FINAL MITIGATION PLAN

**Groundhog Hollow Project
Alexander County, North Carolina**

**DMS Project #: 100049
Contract #: 7417
USACE Action ID: SAW-2018-00450
RFP: 16-007277**

Re: NCIRT Review and USACE Approval of the NCDMS Groundhog Hollow Site / Alexander County / SAW-2018-00450; NCDMS Project # 100049

Figure 11 - Monitoring Plan
Groundhog Hollow Mitigation Project
 Alexander County, North Carolina

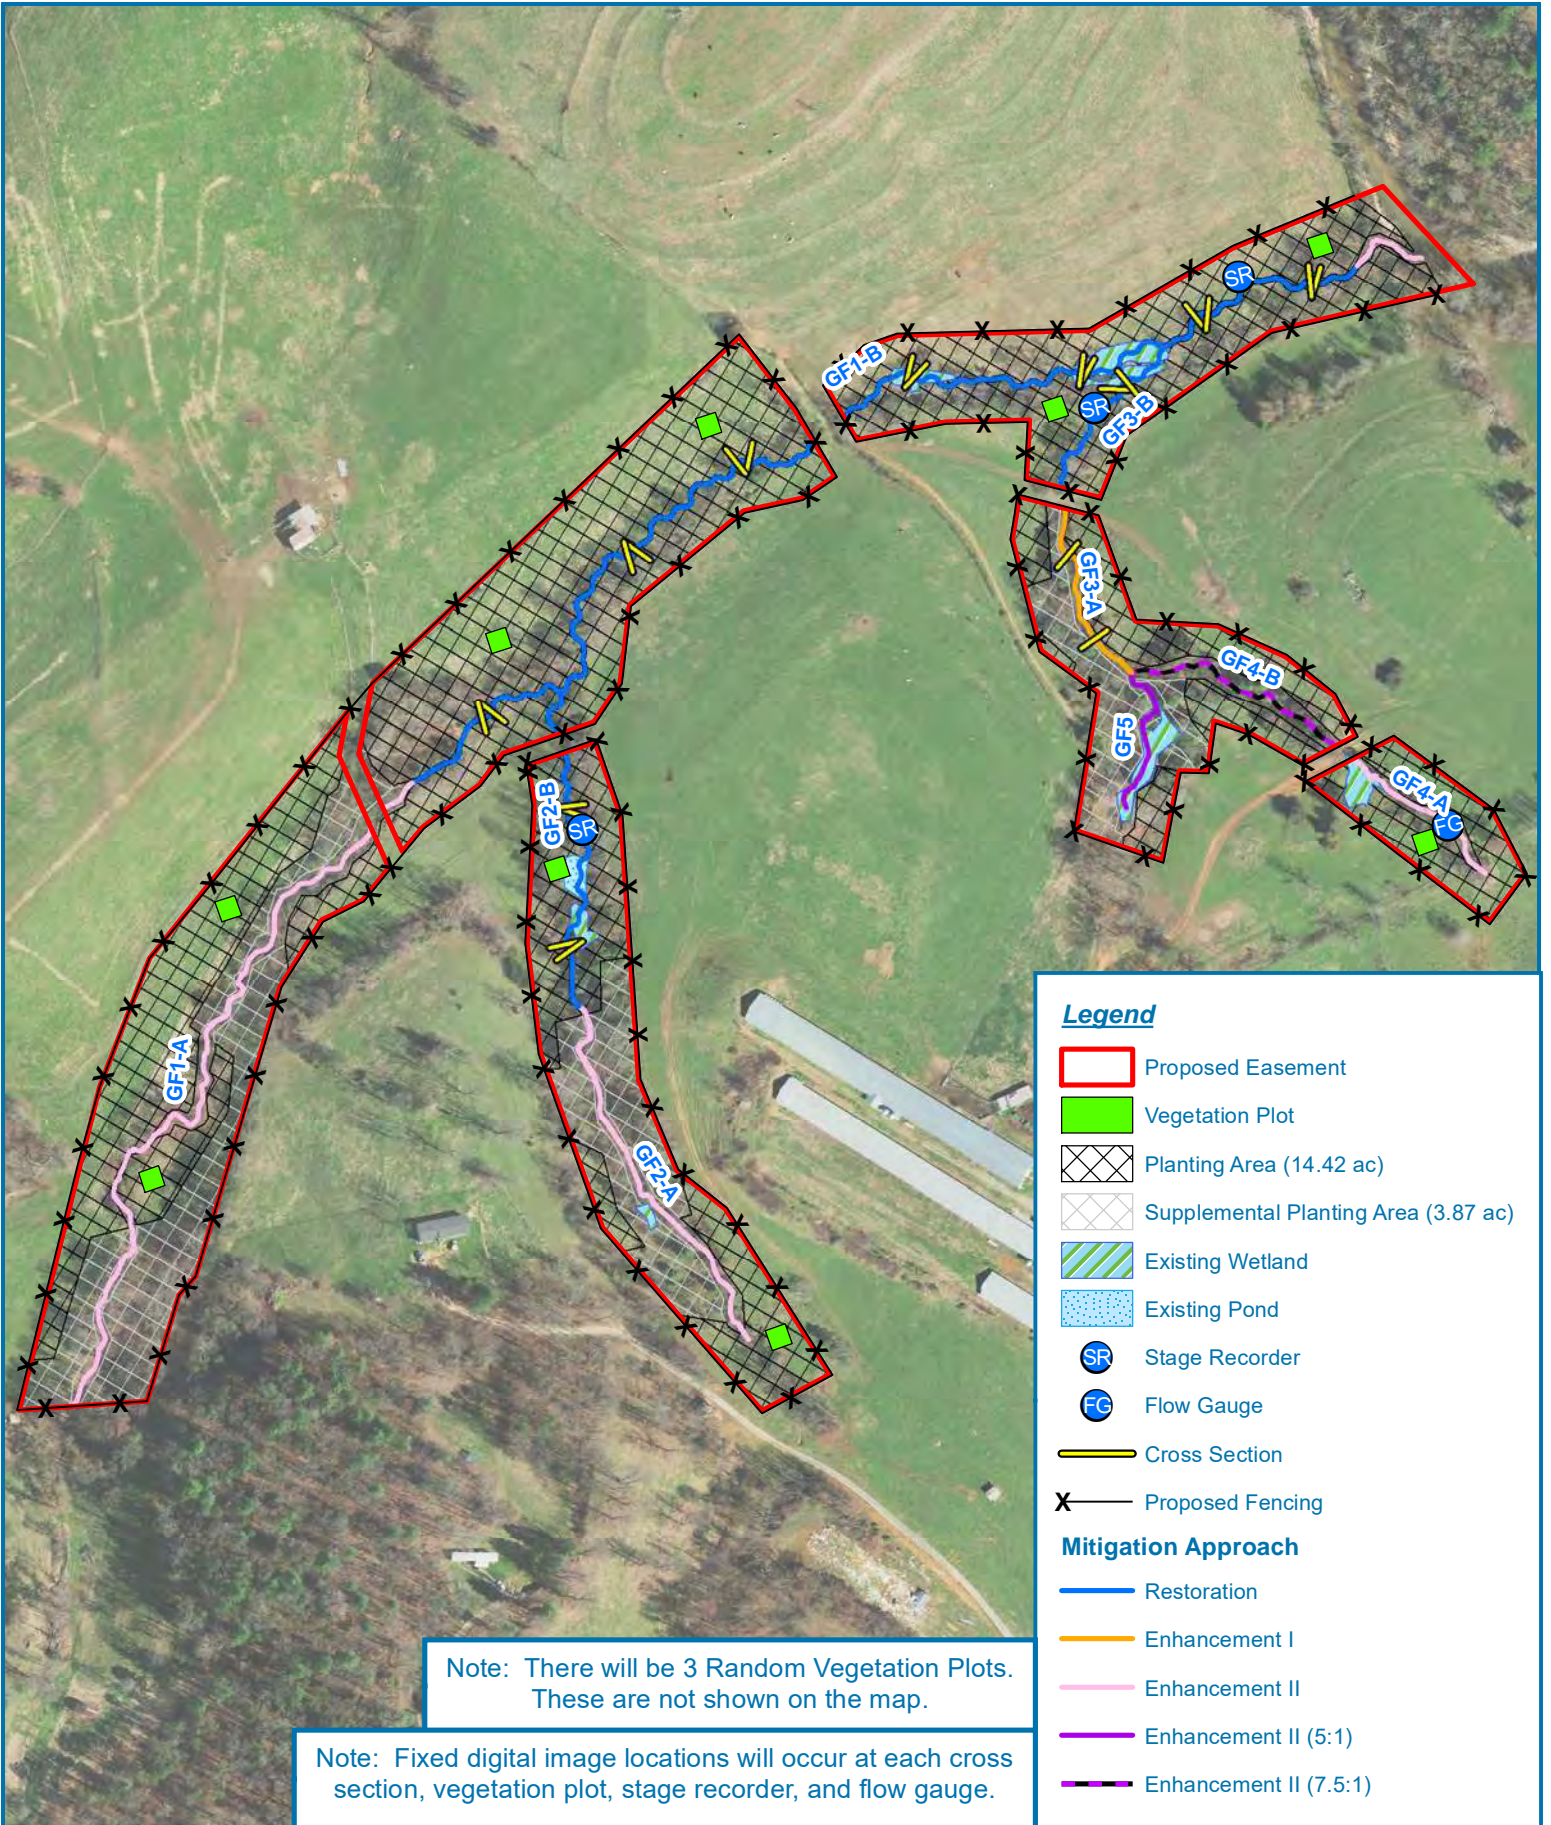
11. Figure 11 Monitoring Plan –
 - a. Please add the existing wetlands layer to the monitoring plan figure.
 - b. Please shift GF2-B & GF3-B recorders just upstream of nearby cross sections.

- c. Regarding the DMS comment about adding stream gauges on intermittent reaches, the IRT 2016 guidance section VI.A.6. (page 9) states that “where restoration *or enhancement* activities are proposed for intermittent streams, monitoring gauges should be installed...”.

2. It would be helpful to depict photo points/digital image stations on Figure 11.
3. Section 4, Functional Uplift Potential: The functional pyramid is cited to show existing conditions for each category, and was used to describe the functional uplift potential of the project, which is appreciated. Please note that the functional pyramid and SQT tool have not been approved for use by the IRT in determining success for mitigation projects. Several of the sections refer to existing conditions as not-functioning or functioning-at-risk. How did you determine this? The SQT forms are not included. It would be beneficial to include the NCSAM assessment.

11. **Figure 11 Monitoring Plan** –
- Please add the existing wetlands layer to the monitoring plan figure.
Existing wetland layer has been added to **Figure 11**.

- Please shift GF2-B & GF3-B recorders just upstream of nearby cross sections.
Stage recorder locations have been moved to the preferred locations.
 - Regarding the DMS comment about adding stream gauges on intermittent reaches, the IRT 2016 guidance section VI.A.6. (page 9) states that “where restoration *or enhancement* activities are proposed for intermittent streams, monitoring gauges should be installed...”.
A flow gauge has been added to reach GF4-A in **Figure 11** and success criteria has been added to **Section 7.1**, further discussed in **Section 8.3**, and included in **Table 16**.

2. It would be helpful to depict photo points/digital image stations on **Figure 11**. **Section 8.2** has been revised to clarify the locations of digital image stations. Specifically, the revised statement reads, "Digital images will be taken at fixed representative locations to record each monitoring event, as well as any noted problem areas or areas of concern. Fixed image locations will exist at each cross section, each vegetation plot, each stage recorder, and each flow gauge." RES believes that these images, along with images of any problem areas, will provide sufficient visual evidence of the Project's progression. Additionally, **Figure 11** has been revised to include a note stating the locations of fixed image locations.

DRAWING TITLE:
EXISTING CONDITIONS

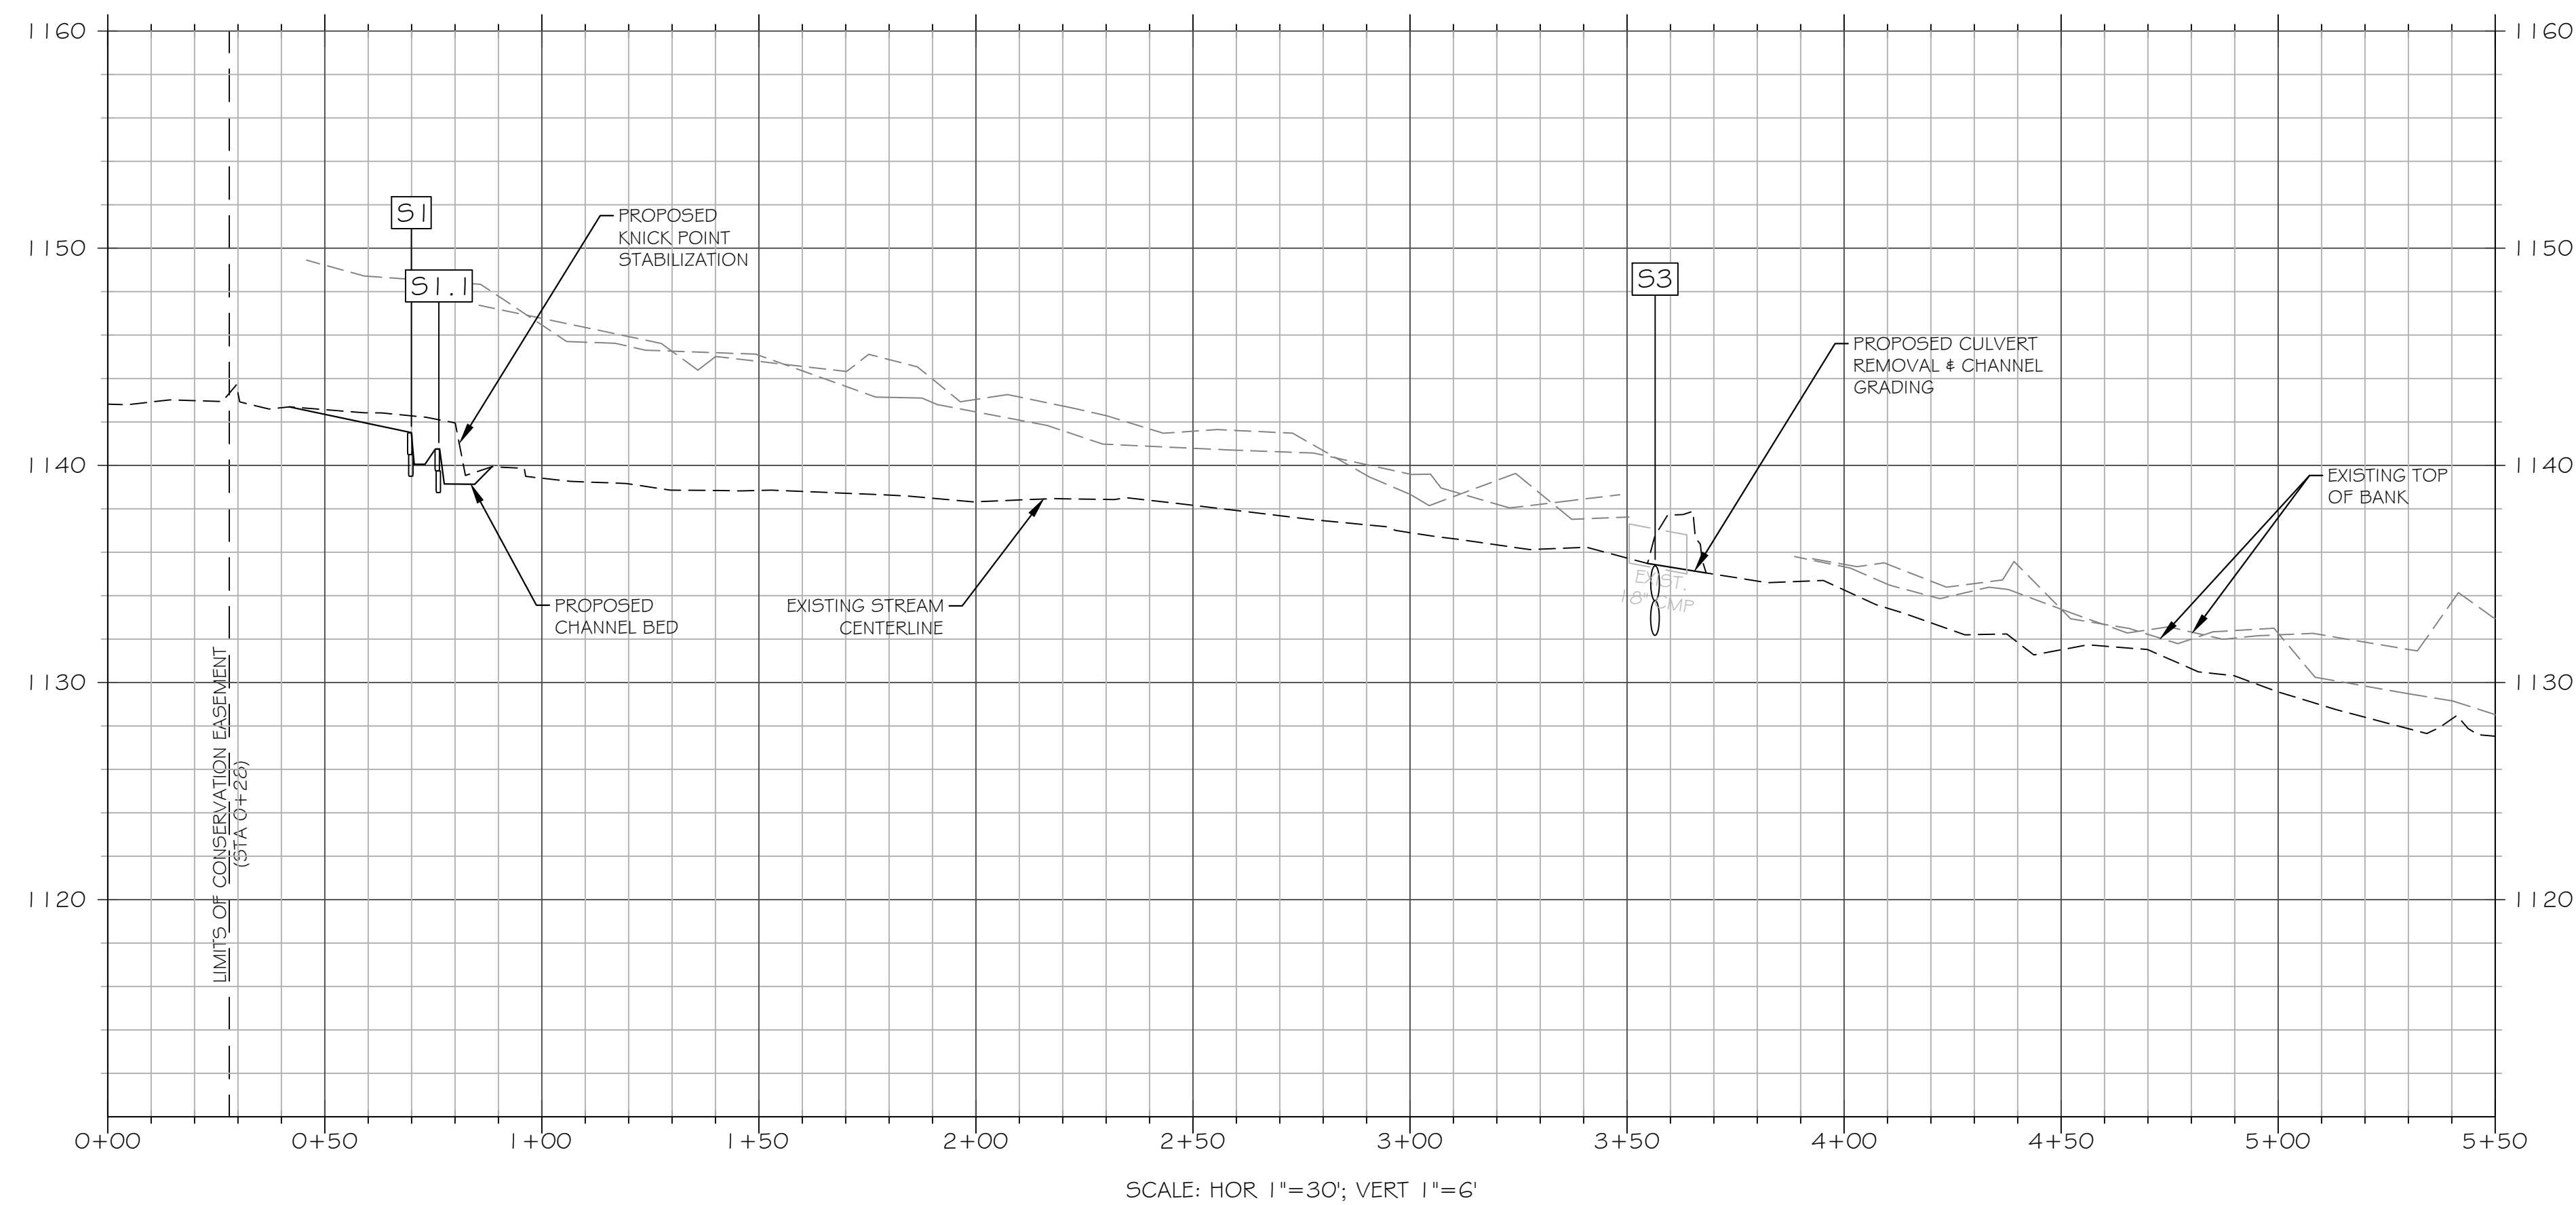
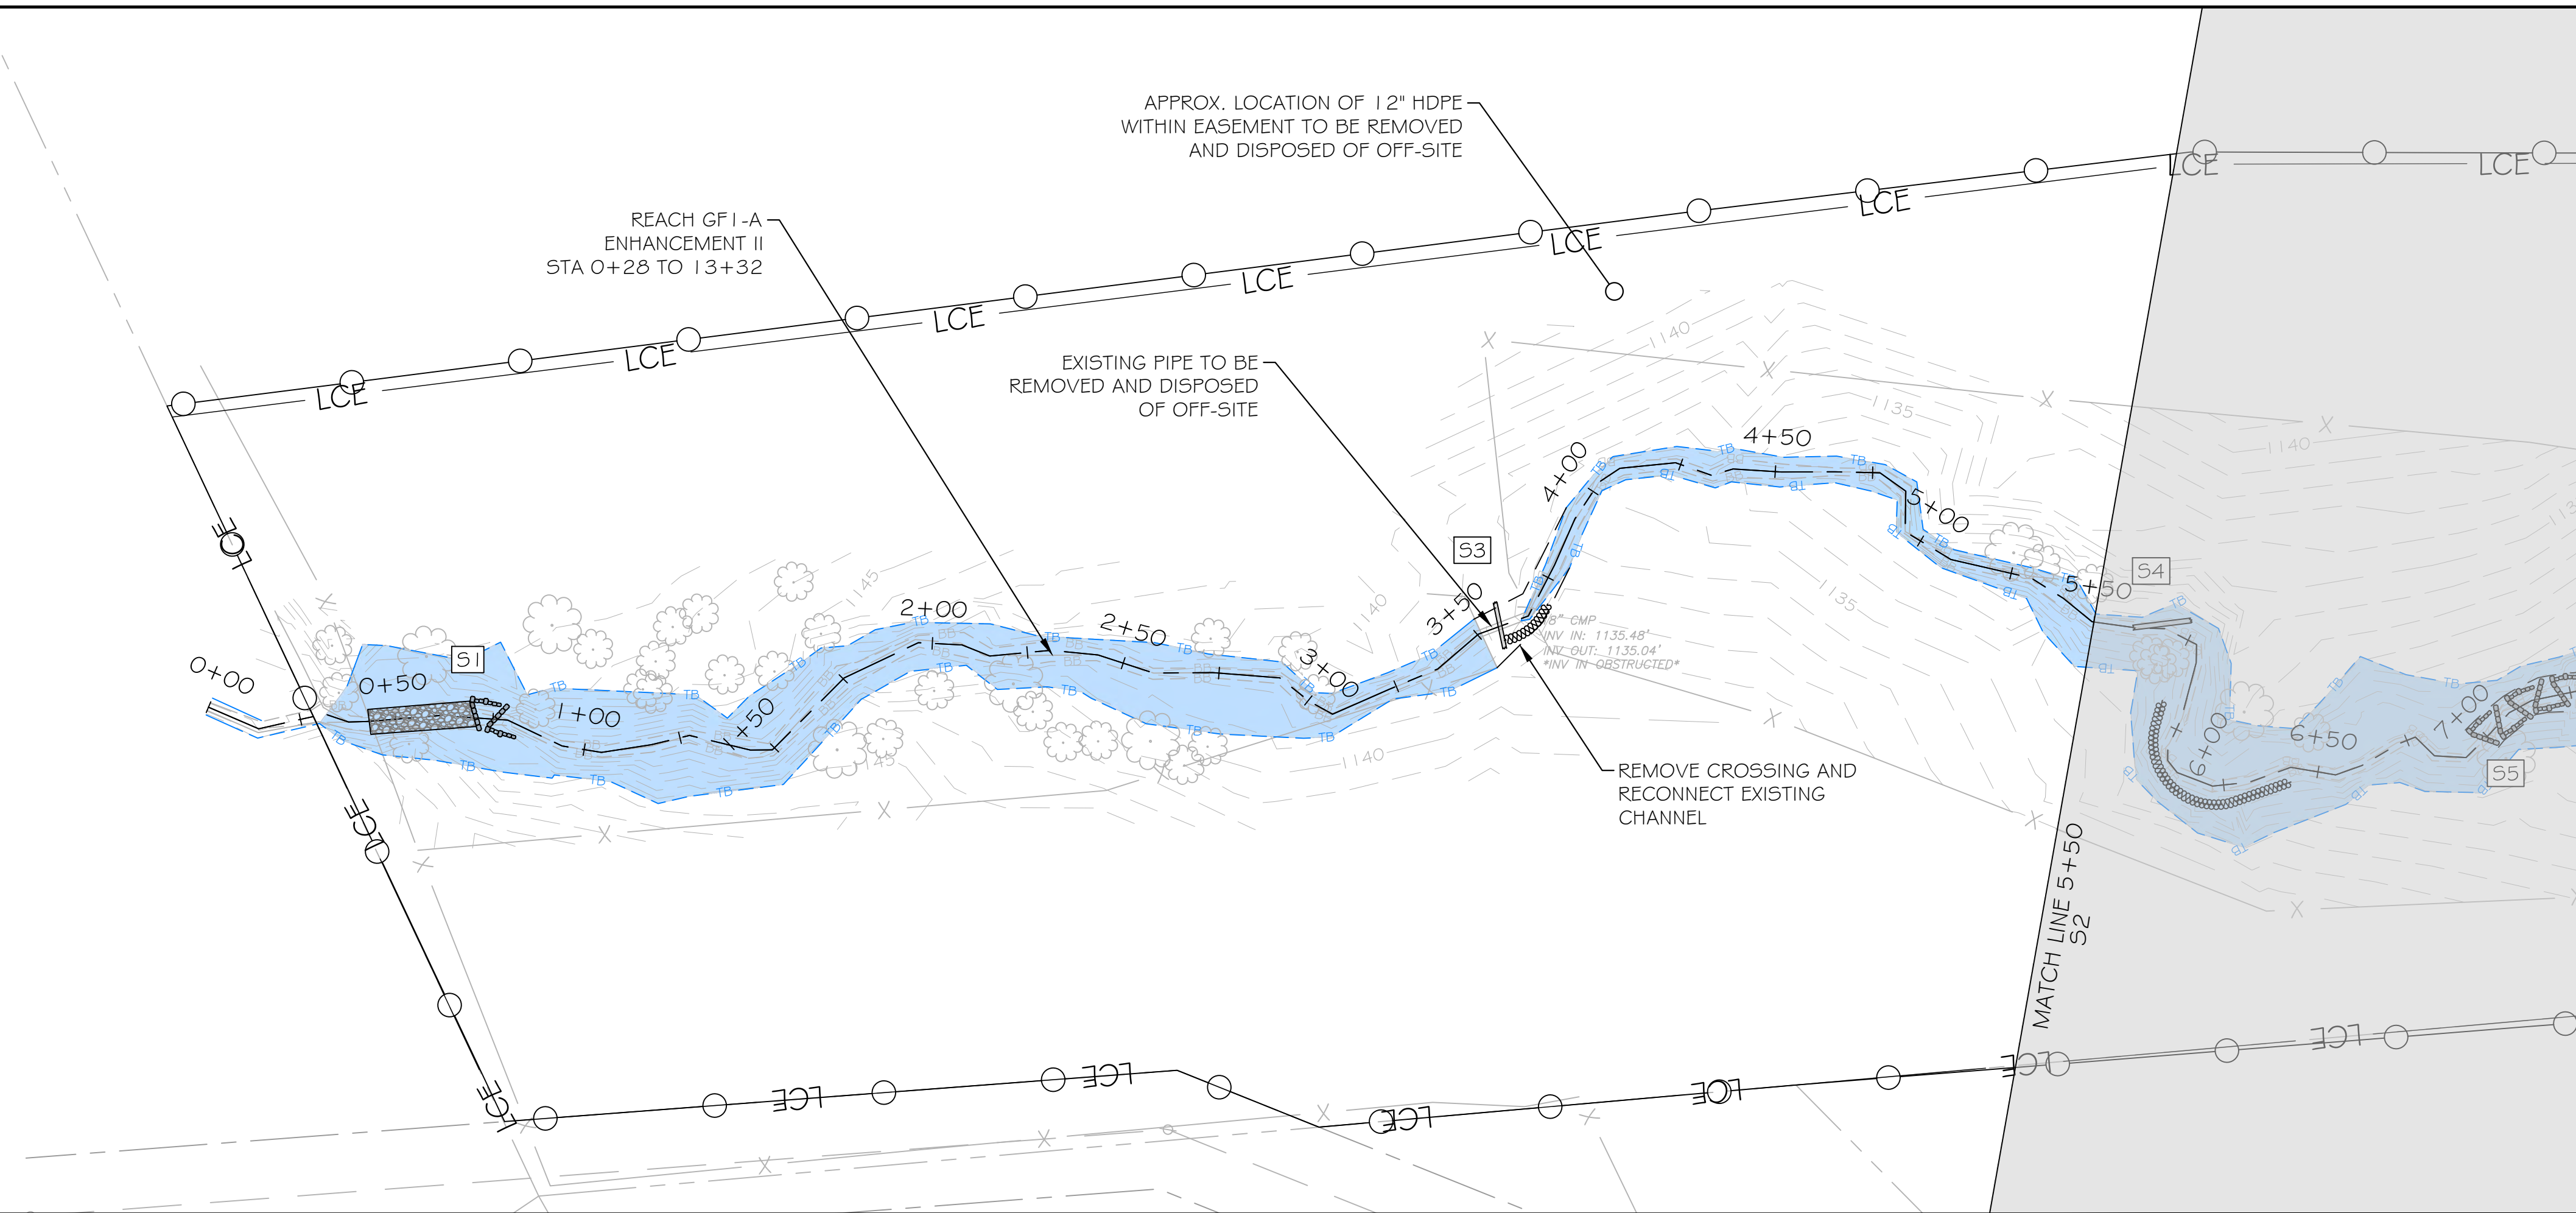
9. Section 6.7, page 33 - Section 3.7 notes that all existing utilities will be removed from the easement; however, Sheet E2 shows three (3) locations where overhead utility lines cross the easement (north of GF1A 12+75; west of GF2B 10+00; east of GF4B 7+50). Have these utility crossings been accounted for in the buffer credit calculation and resulting mitigation credits? If so, please update Figure 10 and add corresponding notes to Table 15. Also, there appears to be multiple poles located within the easement, including one within the proposed grading limits near GF2-B 10+75. Are any poles proposed for relocation?

9. **Section 6.7, page 33** - Section 3.7 notes that all existing utilities will be removed from the easement; however, Sheet E2 shows three (3) locations where overhead utility lines cross the easement (north of GF1A 12+75; west of GF2B 10+00; east of GF4B 7+50). Have these utility crossings been accounted for in the buffer credit calculation and resulting mitigation credits? If so, please update Figure 10 and add corresponding notes to Table 15. Also, there appears to be multiple poles located within the easement, including one within the proposed grading limits near GF2-B 10+75. Are any poles proposed for relocation?
